REFERENCE:	Nova Bus Manuals
SECTION:	14: Heating and Ventilation
RS N°:	MQR 7621-2265
EFFECTIVE IN PROD.:	N/A

SUBJECT:	Bracket installation to add a strain relief on the MCC display screen wires.
JUSTIFICATION:	MCC Driver's Display Electrical Terminal Failure.

Figure 5 - MCC Screen Location.

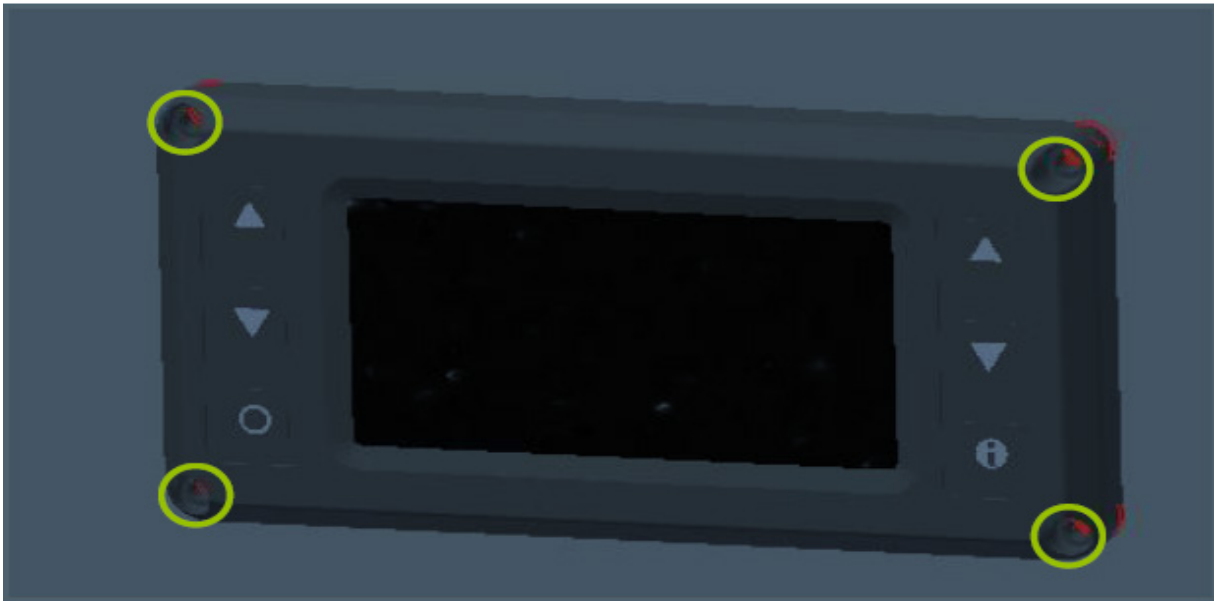
- 1.6. Remove the old M3 screws and replace them with new M3 screws P/N N32320 (see figure 5).

Do not over tighten the screws to avoid cracking the plastic retaining the screen.

Figure 6 - Bracket Installation

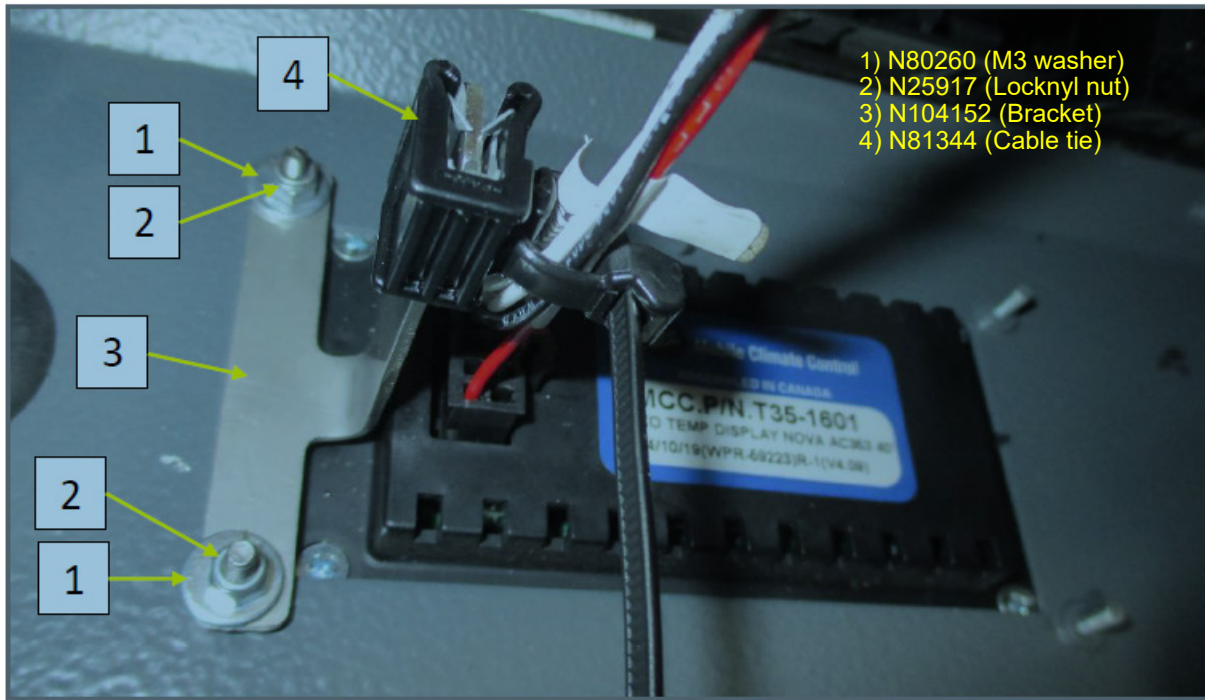
- 1.7. Install the bracket P/N N104152 using the M3 washer P/N N80260 and the M3 Locknyl nut P/N N25917 (see figure 6).
- 1.8. Install the serrated cable tie P/N N81344 using the cable tie, secure the wires (see figure 6).
